NORTHERN REGIONAL PLANNING PANEL

Panel Reference	2018NTH022
DA Number	DA18/0884
LGA	Tweed Shire
Proposed Development	<p>Staged proposal consisting of warehouse or distribution centre, light industry, industrial retail outlet and ancillary office premises and electricity generating works (solar energy system); and additional works.</p> 
Street Address	1 Wollemi Place, Tweed Heads West, NSW 2485
Applicant	Gold Coast Airport Limited c/o Zone Planning
Owner	Gold Coast Airport Limited
Date of lodgement	24 October 2018
Number of Submissions	<p>Two public submissions were received.</p> <p>Submissions have also been received from/on behalf of the following Public Authorities:</p> <ul style="list-style-type: none"> • Essential Energy; • DPI Water; and • Roads & Maritime Services – Transport.
Recommendation	Approval

Assessment Report and Recommendation

FILE NO: DA18/0884

Figure 5 – Extent of Building which Exceeds the Height Limit Shown in Green

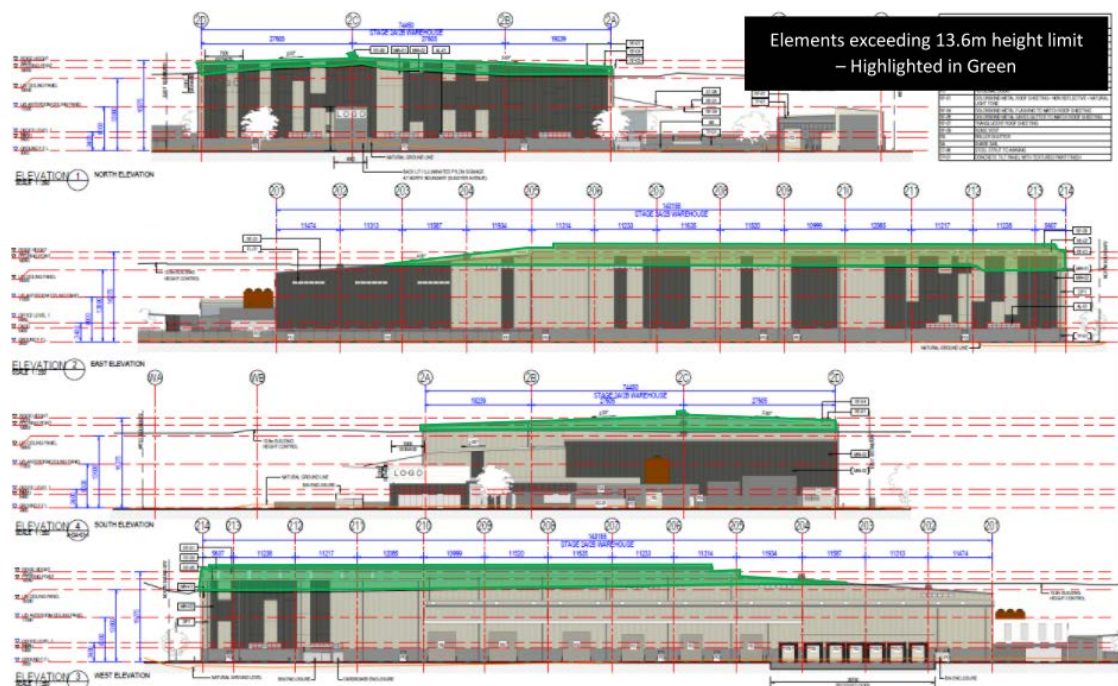
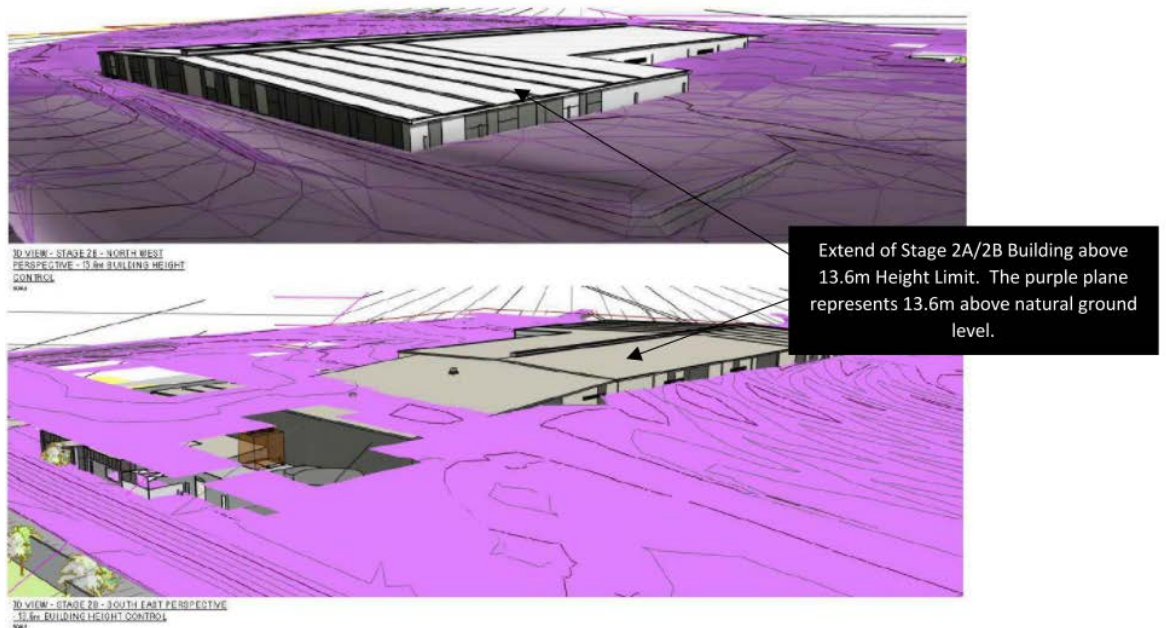
The subject site is limited to a maximum building height of 13.6m. The proposed development incorporates buildings which exceed 13.6m. Specifically, the building associated with Stage 2A / 2B incorporates a maximum building height of 16.26m to the top of roof and 17.0m to top of ridge, as shown in Figures 5 and 6 below.

Accordingly, the application includes a clause 4.6 Request to vary the building height development standard. An assessment of the applicant's clause 4.6 Request is detailed below.

Council officers are satisfied that the provisions of Clause 4.6(3)(b) have been met, in that the applicant has provided sufficient planning grounds to justify contravening clause 4.3 of the TLEP 2014.

Figure 8 – Proximity to OLS Limitation Surface

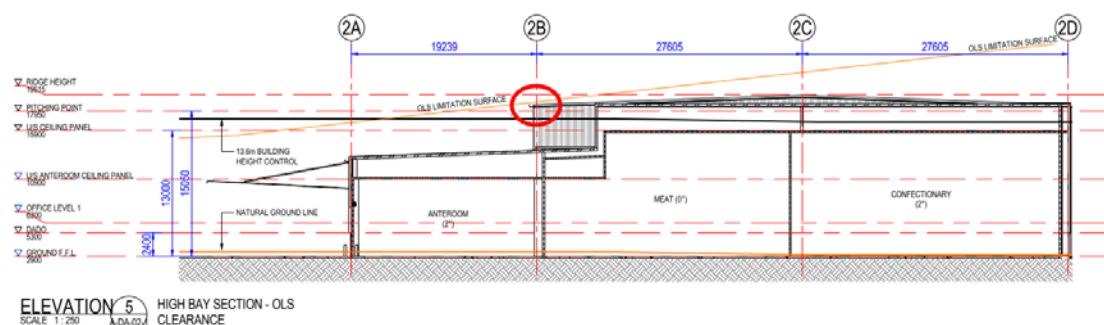
Given the proximity to the airport and the potential for penetration of the OLS (refer to Figure 8 below), the matter was raised with the Gold Coast Airport's consultant to determine what course of action should be taken.

*“At present, the preliminary plans submitted show a building which does not exceed the OLS. Therefore GCAPL responds as per sub-clause 7.8(3)(b); namely, **the development will not penetrate the surface, and thus there is no impediment to Panel granting consent to the application.***

Figure 9 – ANEF Contours 25 to 30 and 30 to 35 apply to the site

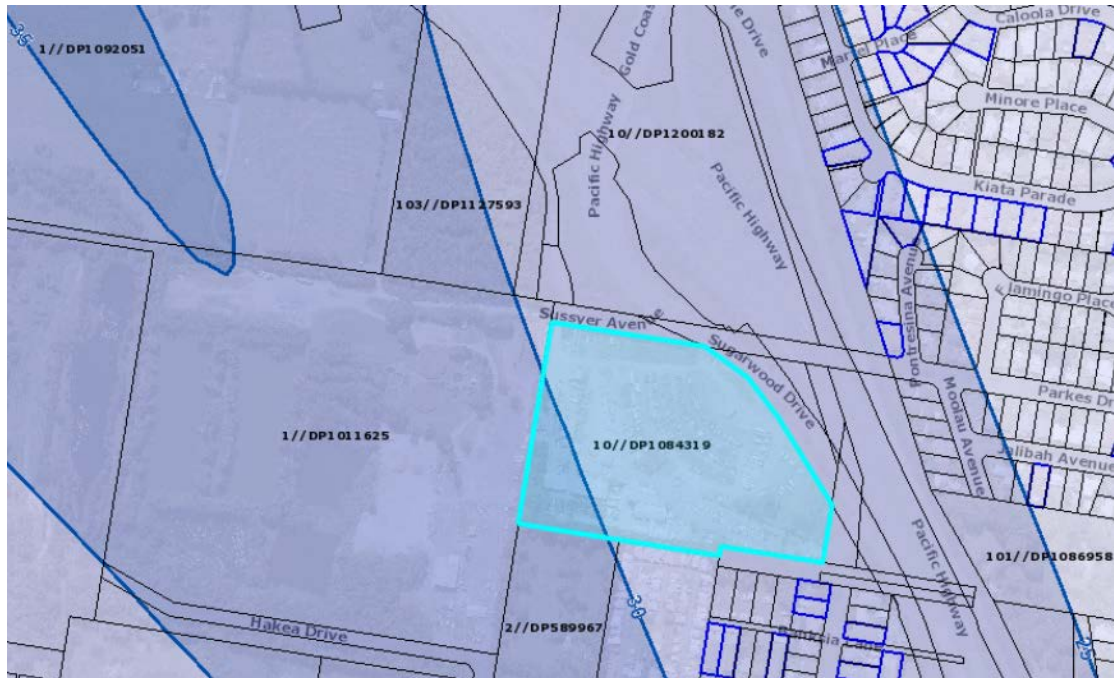
As noted in Figure 9 below, the subject site is near the Gold Coast Airport and is mapped as being within the ANEF 25 to 30 and 30 to 35 contours. As such, the provisions of clause 7.9 apply.

Council officers have provided the following comment in noting that the proposal is considered satisfactory in meeting the applicable noise attenuation measures:

“CRG Acoustics was engaged to provide advice with respect to the impacts of aircraft noise on the development. The assessment makes a number of recommendations with respect to the construction and ventilation of the proposal which have been incorporated into the proposed development plans. The assessment concludes that based upon the adopted noise limit criterion, overall, the proposed development can be designed to comply with acceptable design sound levels.

Figure 10 – Pylon Sign Requiring Concurrence

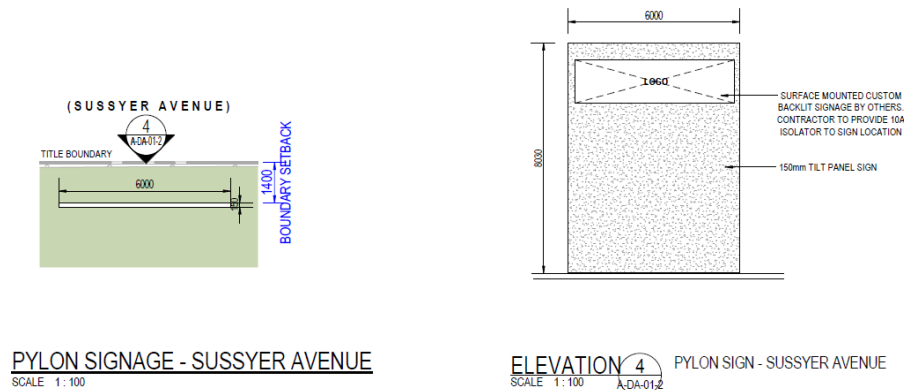
The proposed development incorporates a pylon sign (as shown in Figure 10 below) adjacent to the Sussyer Avenue road frontage. Being greater than 20m² and within 250m of and visible from a classified road, the sign triggers the provisions of clause 18, thereby requiring the concurrence of the RMS.

Figure 17 – Western Boundary Landscaped Buffer

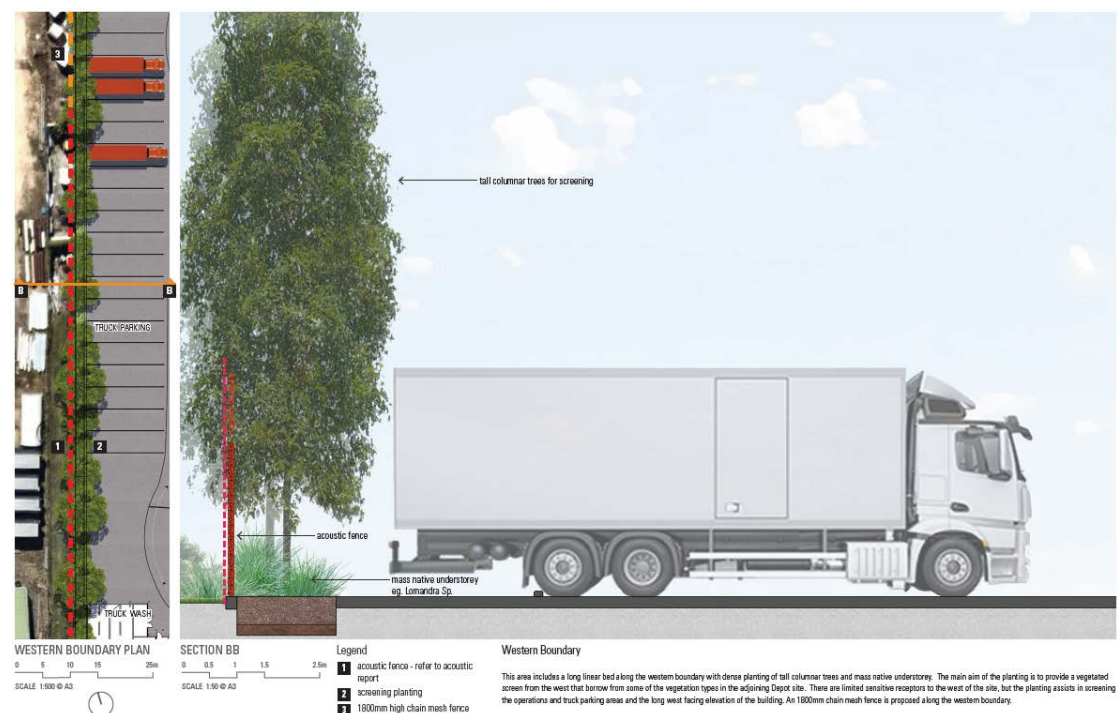
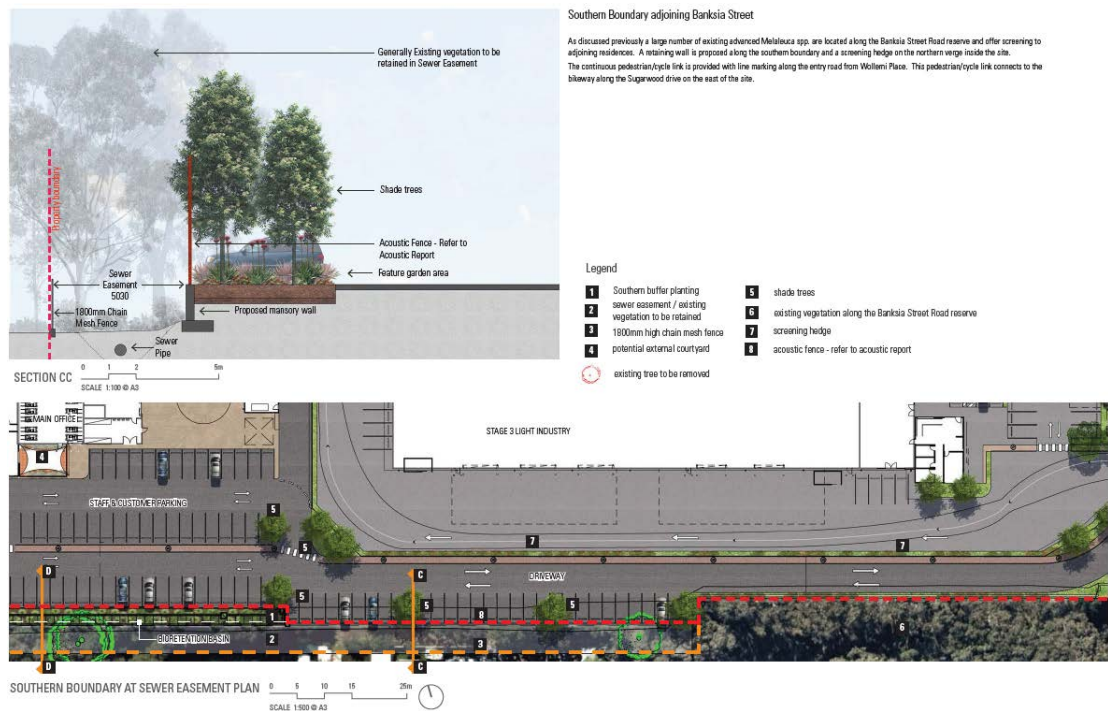
The applicant has requested a variation to this control, proposing a 2m wide landscaping buffer along the western boundary and a variable width buffer of 5.03m to 8.03m along a large portion of the southern boundary. Refer to Figures 17 and 18 below.

The applicant's justification notes that the proposed landscaping along the southern and western boundaries is designed to provide amenity both internally and externally.

Council officers consider that the proposed variation to landscape buffer widths is supportable, with acceptable landscaping provisions being proposed, along with acoustic walls for residential amenity (noise) purposes.

Figure 21 – Forest Red Gum (1) and Broad-leaved Paperbark (2)

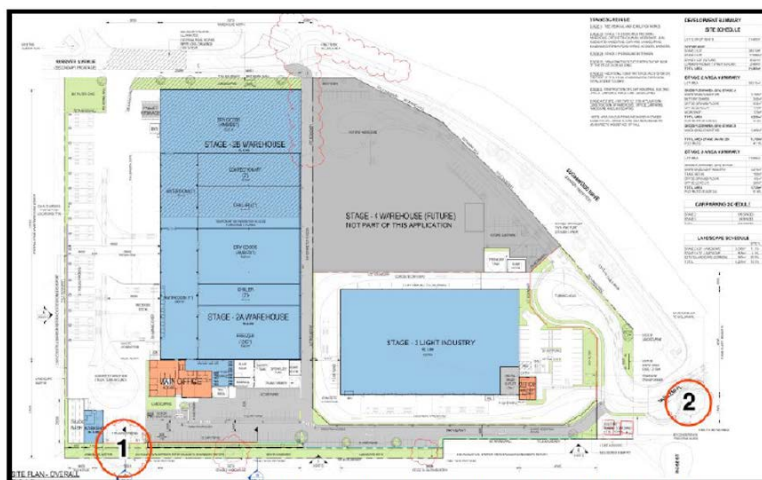
As noted previously, the proposed development incorporates the removal of existing vegetation from the subject site. The initial proposal included the removal of a mature *Eucalyptus tereticornis* (Forest Red Gum), which is a Preferred Koala Food Tree scheduled under the *Tweed Coast Comprehensive Koala Plan of Management 2015* (TCCKPoM), as well as significantly sized remnant *Melaleuca quinquenervia* (Broad-leaved Paperbark). Refer to Figure 21 below. The applicant proposed off-site offsetting for the removal of the Forest Red Gum.

Council officers raised concerns with the applicant with regard to the proposed removal of both species, noting that Council's recent upgrade of the sewer main adjacent to the southern boundary had been undertaken without the need for removal of Forest Red Gum. It was also considered reasonable to amend the proposed works around the Wollemi Place upgrade to enable the Broad-leaved Paperbark to remain in place.

Figure 23 – Proposed Acoustic Wall Treatment

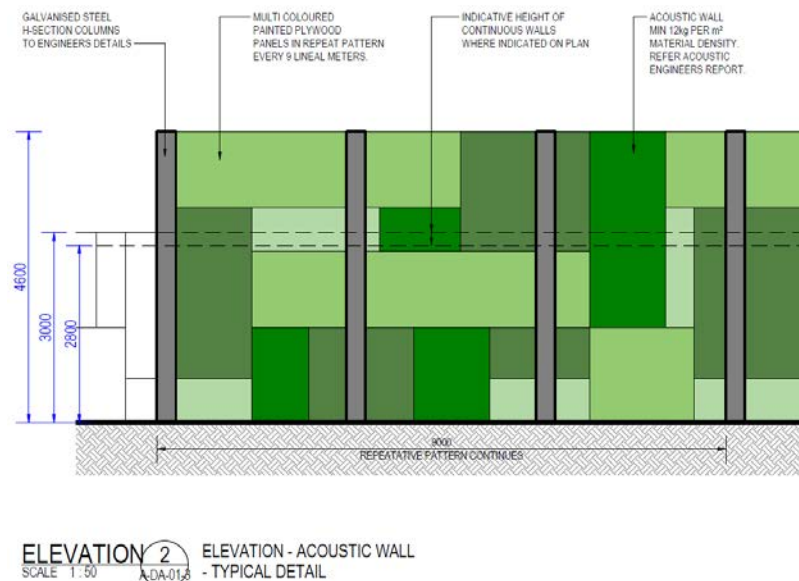
Given the limited ability to screen such tall structures with vegetation, the proposed treatment of the acoustic walls (as shown in Figure 23 below) is considered to be satisfactory.
